TONBRIDGE & MALLING BOROUGH COUNCIL

A G E N D A

5. TM/21/02001/FL - Leybourne Lakes Country Park, Malling 15 - 34
Road, Larkfield

6. TM/20/02749/OAEA - Land South of Barming Station and East 35 - 196
of Hermitage Lane, Aylesford

Site Layout

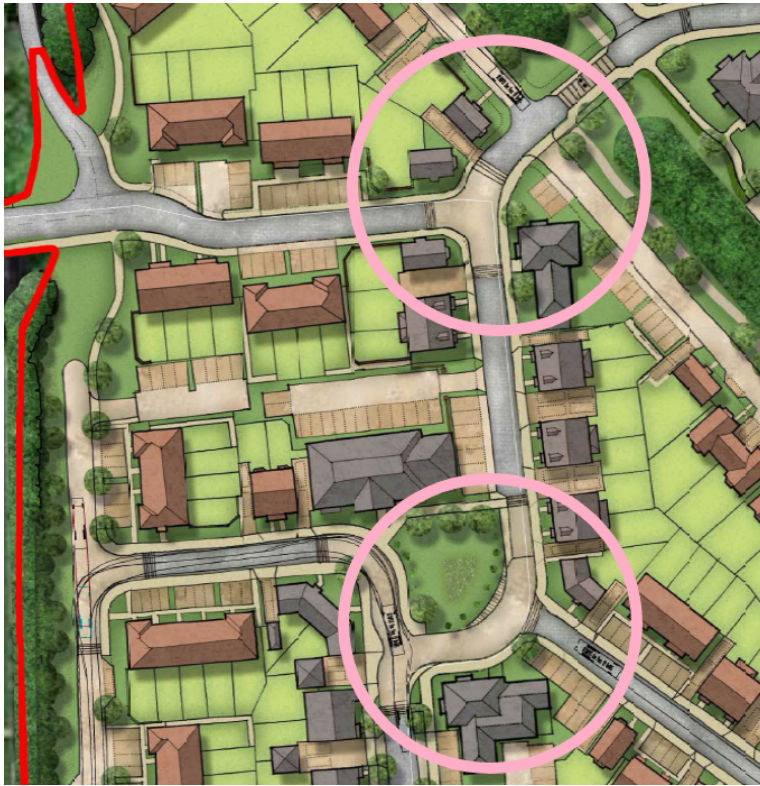
Revised drawings including tracking are provided at Appendix A on drawings 5407.007 Rev A and 5407.009 Rev A. Please extend the tracking to cover the junctions shown below:

Additional space is needed on the southern junction shown in the extract above. Whilst the layout needs to be constrained and convoluted to deter through trips, the current proposed layout may lead to conflict.
